ADDENDUM NO. 3

Project: American Legion Core Academic Renovation

**AMERICAN LEGION HIGH SCHOOL
CORE ACADEMIC AND CAMPUS RENOVATION
SACRAMENTO CITY UNIFIED SCHOOL DISTRICT
DSA App # 02-116158; DSA File # 34-H7**

ADDENDUM # 3 – REBID
July 25, 2018

UNIT:	SHT.	OF	SHTS.
JOB NO.	DATE: JULY 24, 2018		
DRAWN BY NE	DRAWING NO: ADD-3R		
CHECKED ST	1/GS102

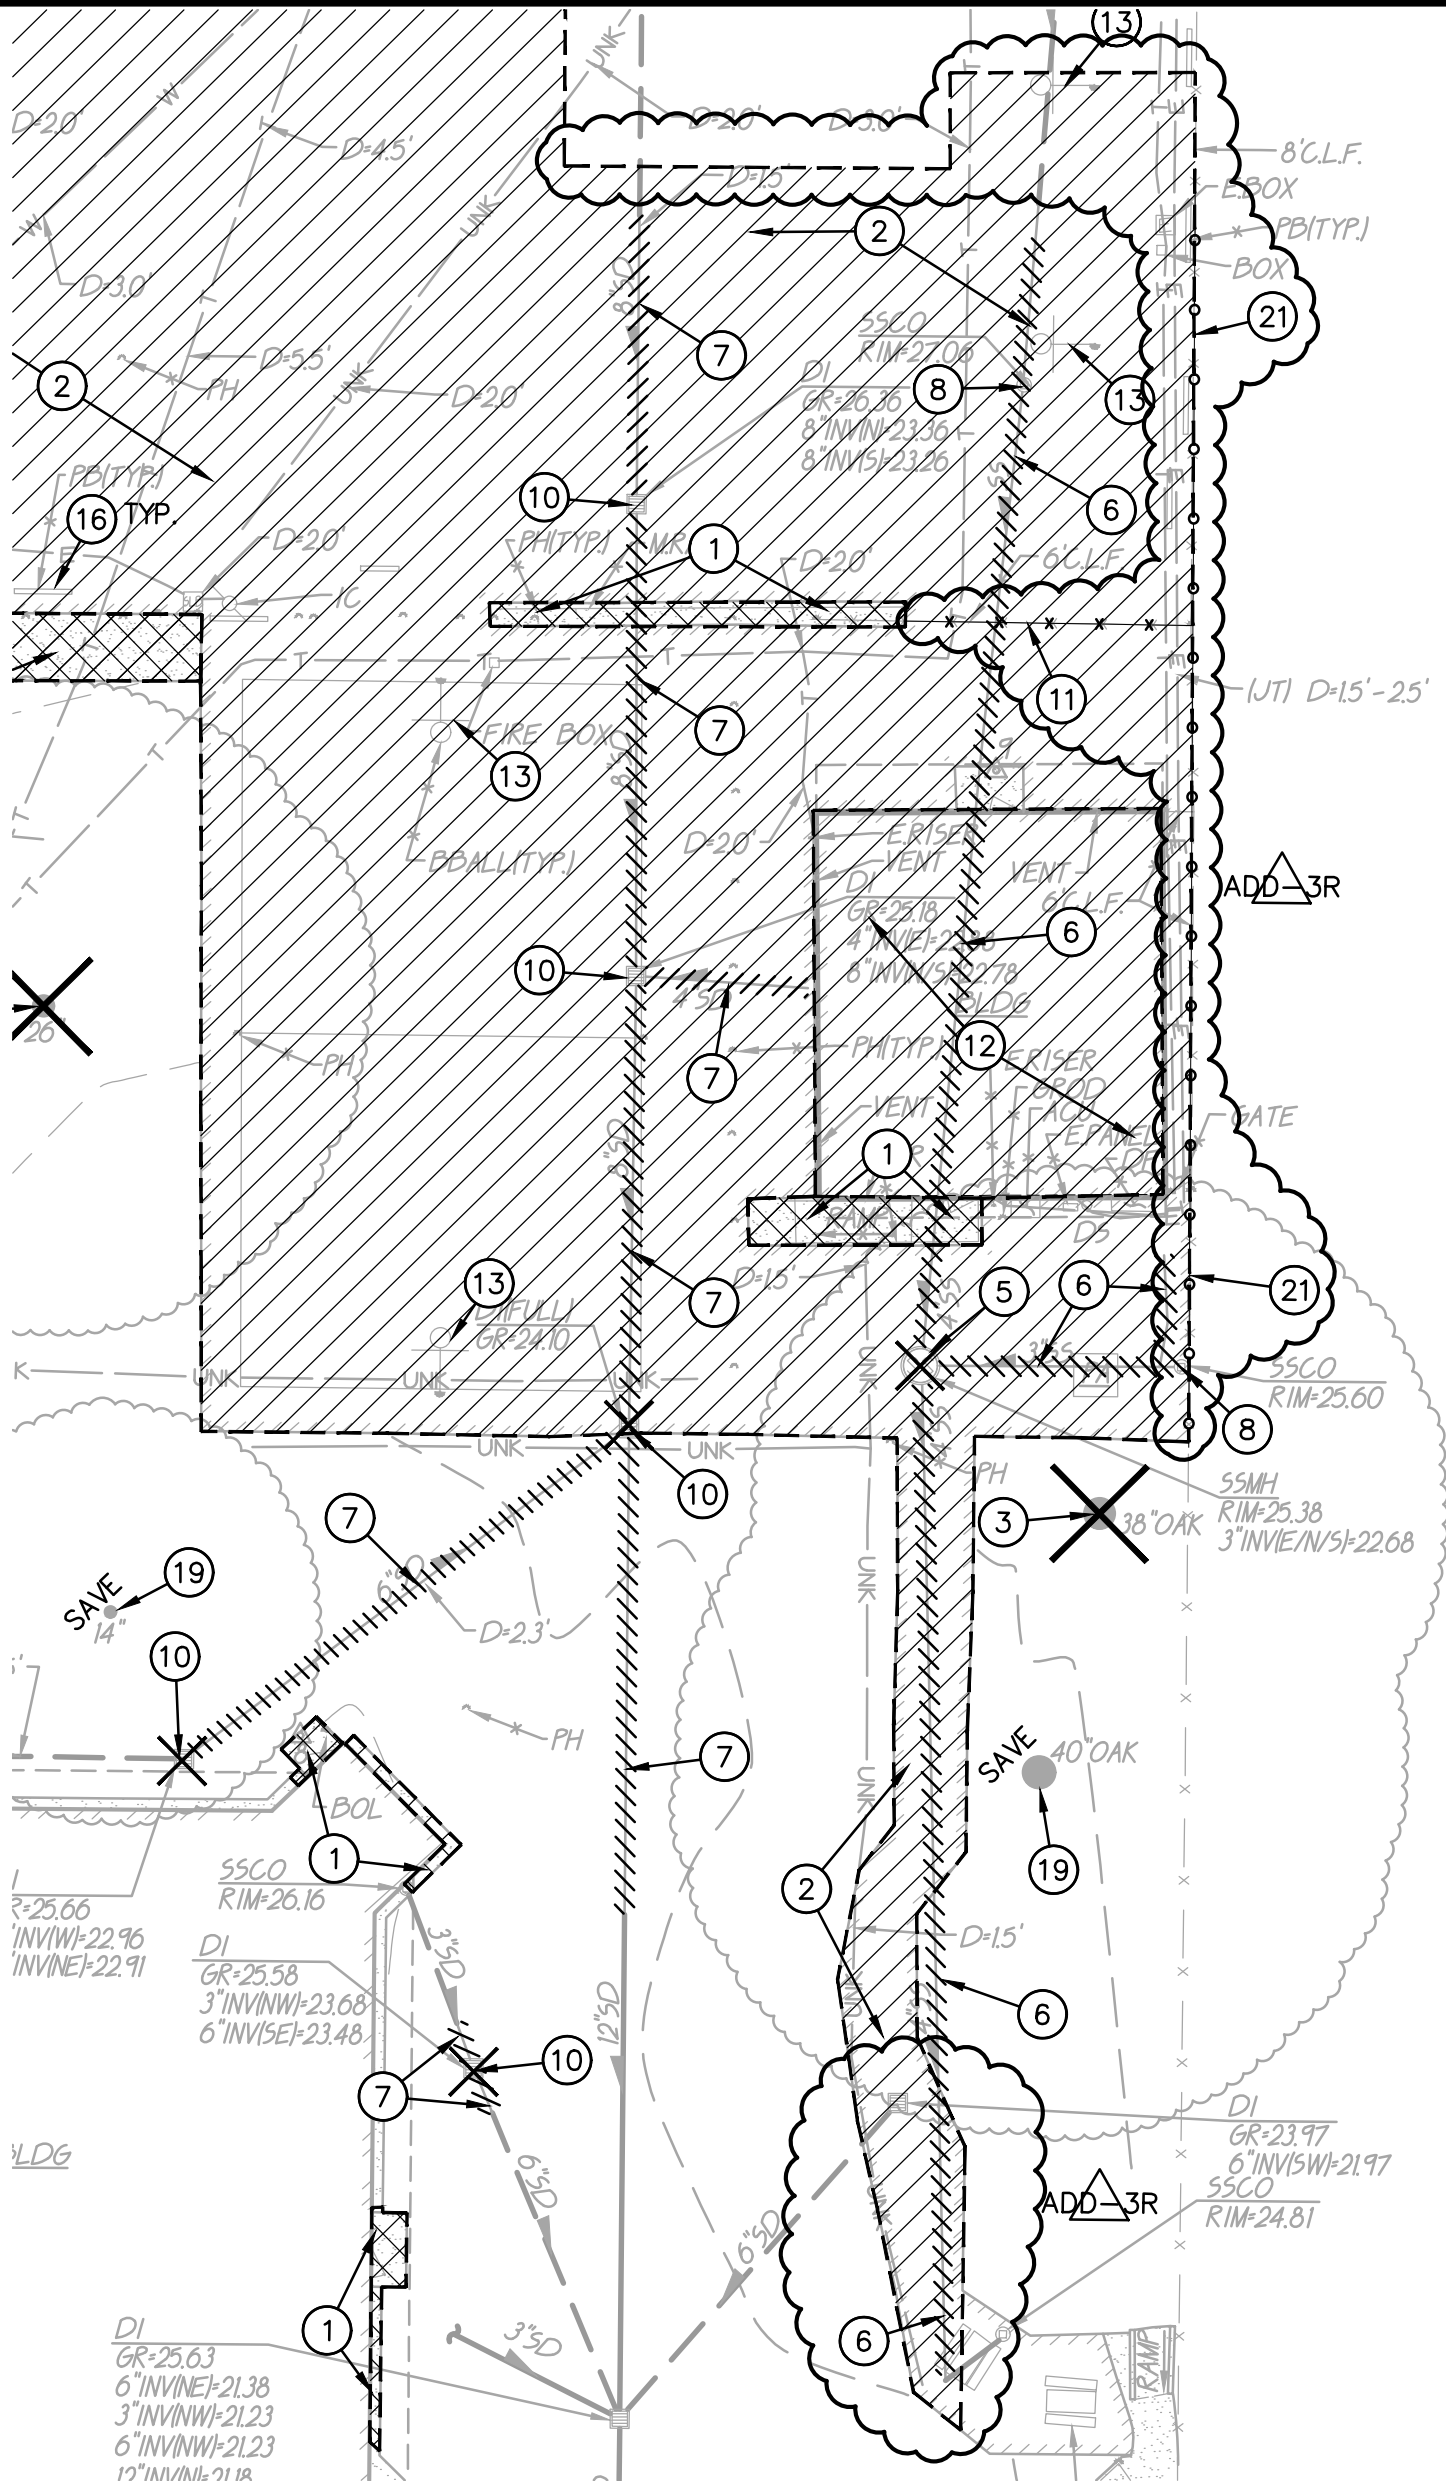
ITEM # 3R.8 Sheet ADD-1R GS102 – Enlarged Site Plan: Update this Sheet as shown on the attached **ADD-3R 1/GS102**. All changes have been clouded.

- 6.47 DOOR TO BE PERMANENTLY CLOSED AND LOCKED.
- 6.49 THRESHOLDS SHALL HAVE A 1/2" MAX. HEIGHT INCREASE FROM FINISH GRADE OF NEW CONCRETE AS PER CBC 11B-404.2.5.
- 6.54 CLOSURE PANEL, REFER TO DETAILS A5 & B4/A-542.
- 6.55 PORTABLE TO BE PLACED ON EXISTING PAVING. BLOCKING PLATE AND TOP PLATE AS SHOWN ON SHEET F1.21 TO BE SALVAGED AND REUSED. SILL PLATE AS SHOWN ON SHEET F1.21 TO BE NEW. SIZES AND INSTALLATION AT NEW LOCATION TO MATCH EXISTING AS SHOWN ON SHEETS F1.02 & F1.21.

C1.1A

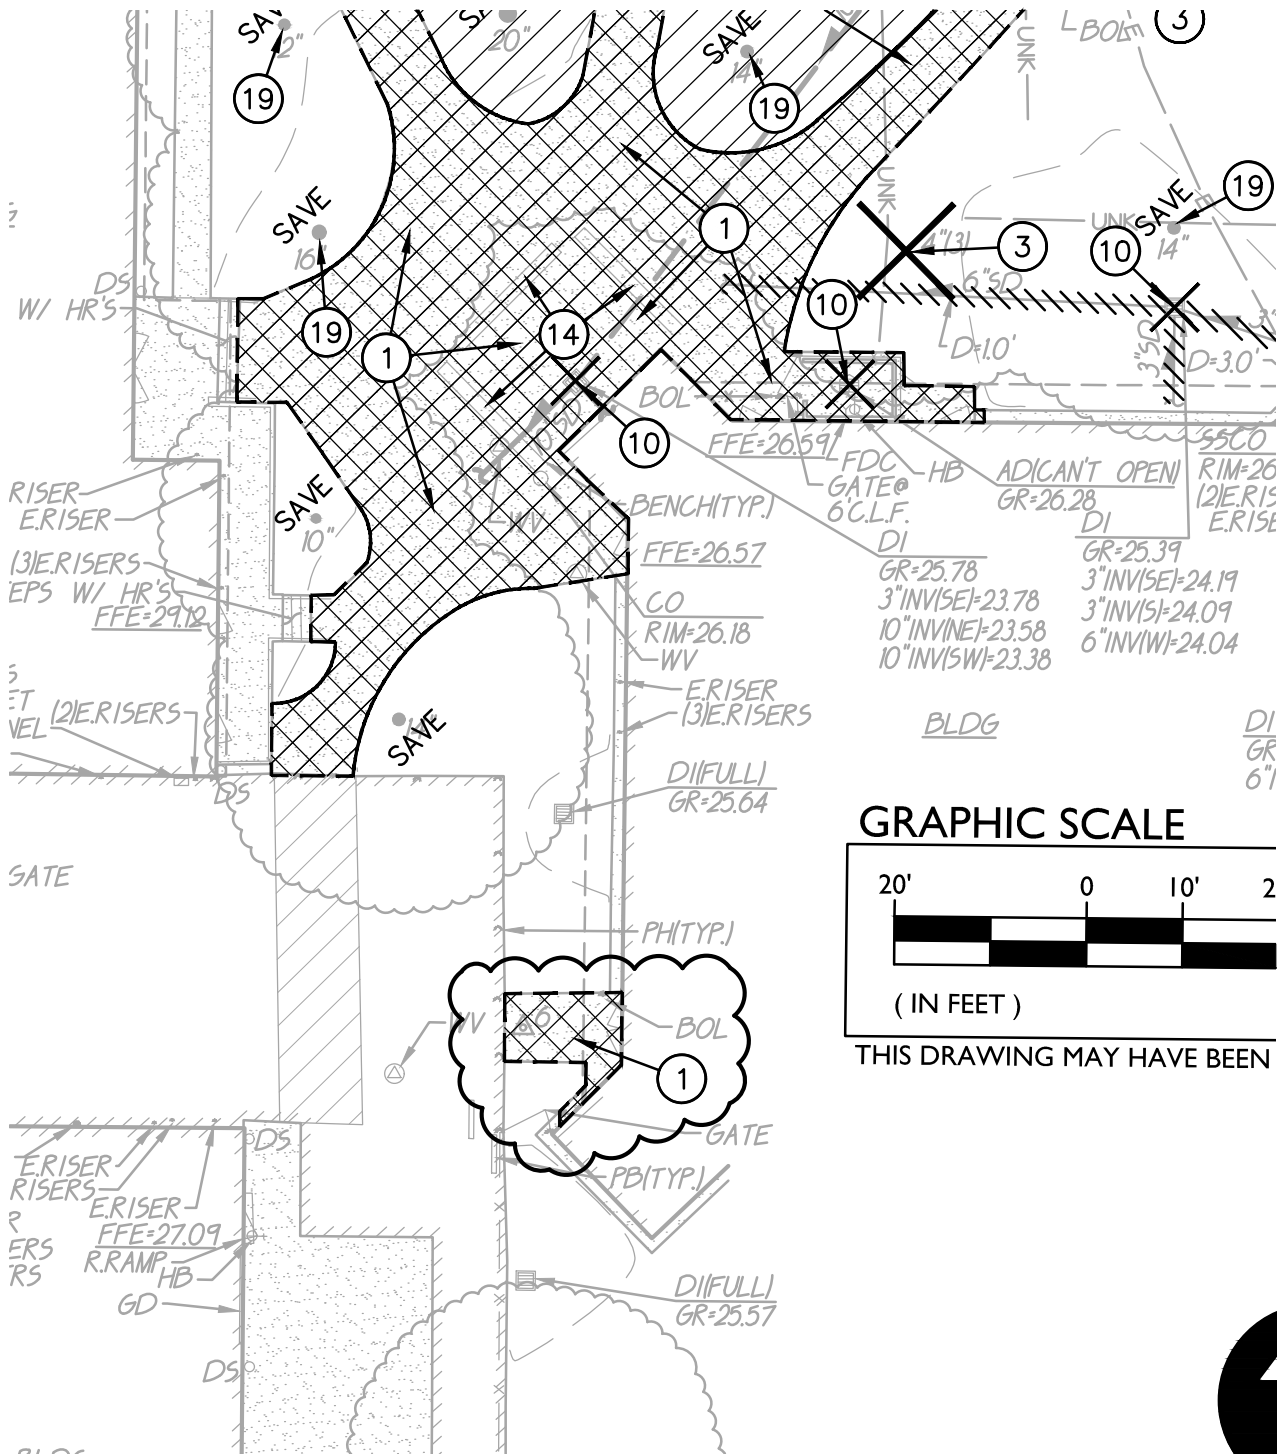
ITEM # 3R.9 Sheet ADD-1R C1.1 – Demolition Plan: Update this Sheet as shown on the attached **ADD-3R C1.1A** and **ADD-3R C1.1B**. All changes have been clouded.

21. REMOVE AND SALVAGE CHAIN LINK FENCE AND POSTS. REMOVE AND DISPOSE OF FOOTINGS. REINSTALL FENCING PRIOR TO COMPLETION OF PROJECT.
